Access Report

**NCC Vol 1 – Part D3 & Access to Premises
Standards 2010 – Assessment Report**

Nepean Hospital Redevelopment

Revision 1

Figure No. 12 – Accessible car parking spaced adjacent to the ED Entry

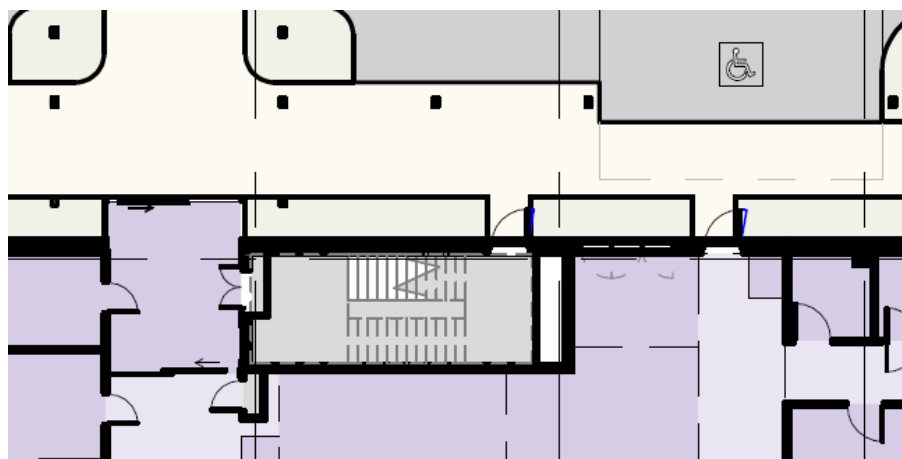
It is noted that the Emergency Drop Off area contains provision for an accessible car parking space. The accessible car parking space is required to be designed in accordance with AS 2890.6.
